Contract #: 04-0120F4Cty: SF/ALA Rte: 80 PM: 13.2/13.9File #: 69.25B**QUALITY ASSURANCE -- NON-CONFORMANCE REPORT****Location:** Changxing Island, Shanghai, PRC**Report No:** NCR-000278**Prime Contractor:** American Bridge/Fluor Enterprises, a JV**Date:** 26-May-2009**Submitting Contractor:** Zhenhua Port Machinery Company, Ltd (ZPMC), Changxing Island**NCR #:** ZPMC-0252**Type of problem:**

Reference Description: Missing backing bar at East Tower, Lift 1, 18m Diaphragm CJP weld**Description of Non-Conformance:**

NON-CONFORMANCE REPORT TRANSMITTAL

Subject: NCR No. ZPMC-0252

REPORT OF ULTRASONIC EXAMINATION

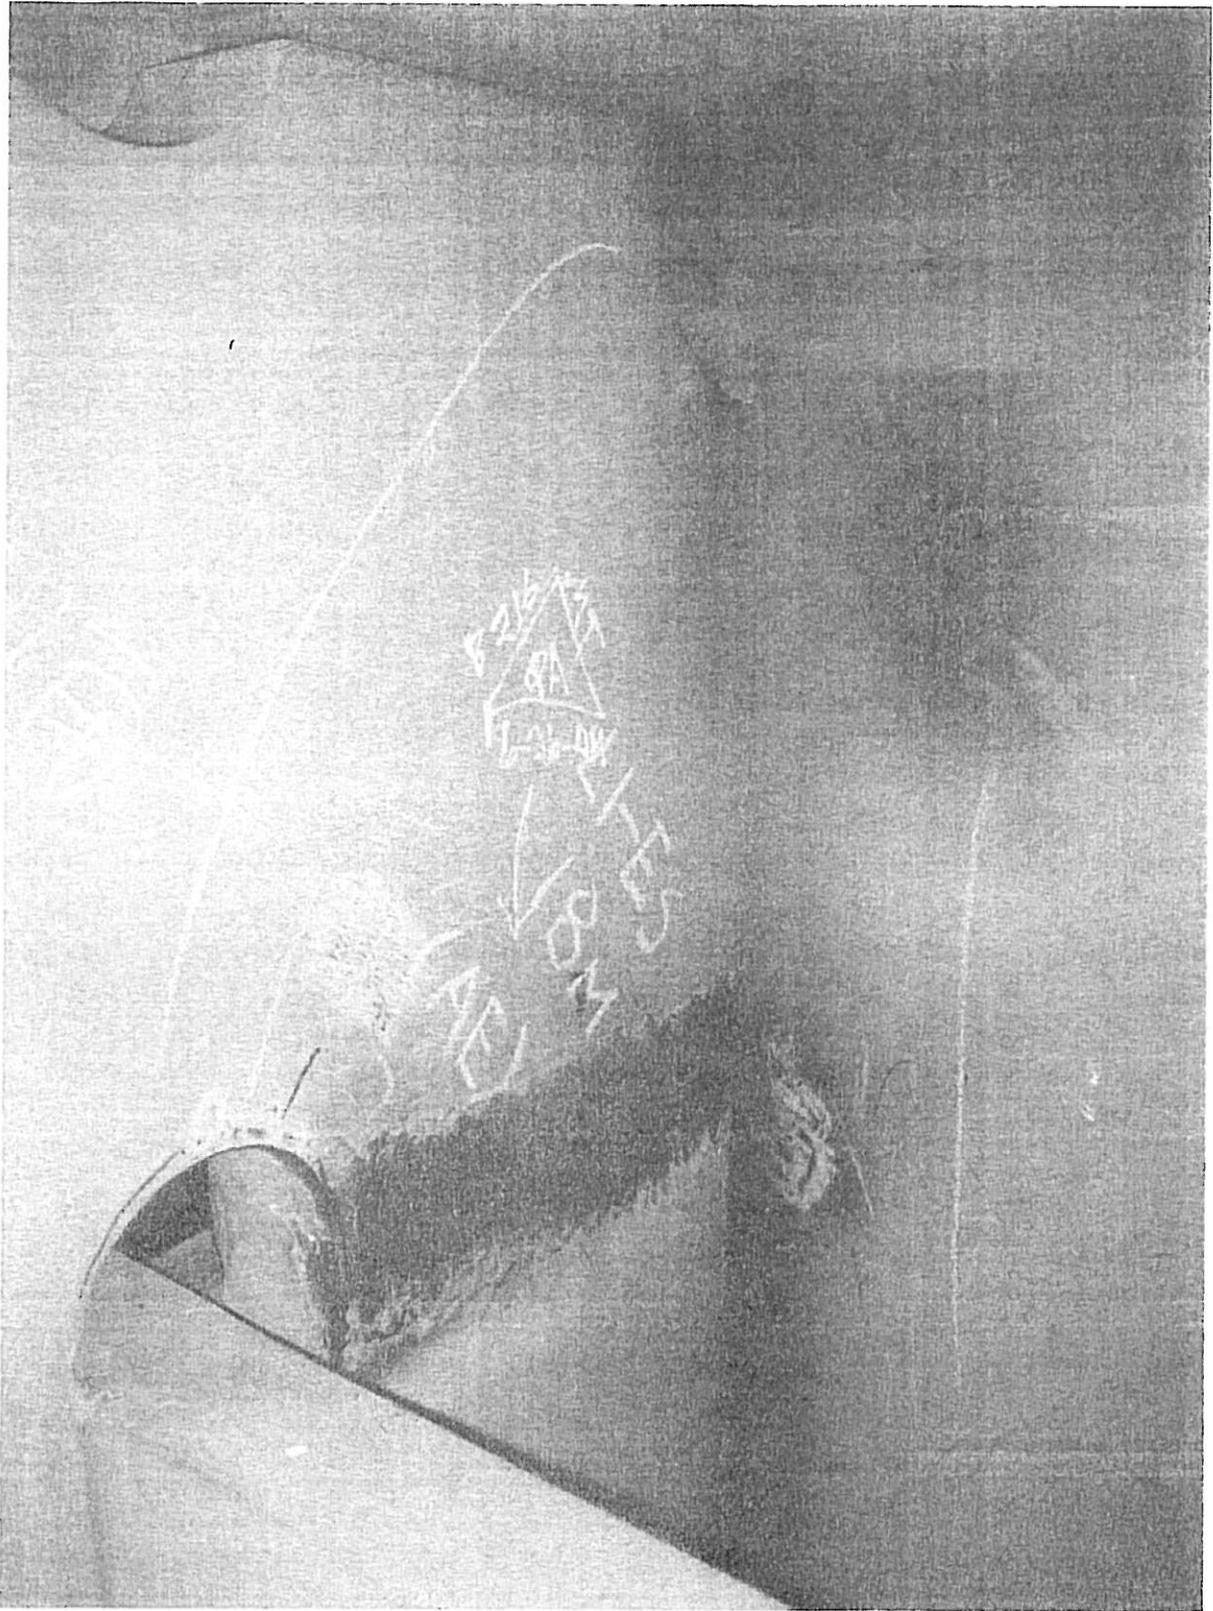
During random after-blast visual verification of East Tower, Lift 1, QA observed that there was no backing bar at 18m diaphragm weld joint ESD1-A167G/H-141.

The proposed resolution is not acceptable. The attachment includes only a picture of the completed weld, and does not include any inspection documents showing that the weld is acceptable.

Please provide documentation of the weld repairs that were performed and that the repairs were acceptable. The Department will review the Contractor's proposal to close Non-Conformance ZPMC-0252 at that time.

About ESD1-A167G/H-141, ZPMC ground the weld back and repaired after VT. The MT, UT were performed to make sure no problem about this weld.

Base metal inspected per AWS D1.5-2002 Section 6.19.5 0° UT OK.

WELD IDENTIFICATION 焊缝部件编号	INDICATION NO. 指示号	PROBE ANGLE 探测角度	FROM FACE 检测面	LEG (次数)	DECIBELS分贝				DISCONTINUITY 不连续性					Discontinuity Evaluation 缺陷估计	Remark 备注	
					Indication Level	Reference Level	Attenuation Factor	Indication Rating	LOCATION OF DISCONTINUITY 不连续位置(mm)							
									a	b	c	d	Length 长度			Sound Path 声程
ESD1-A167G/H-141		70				32									ACC.	100%
		60				34									ACC.	100%
BLANK
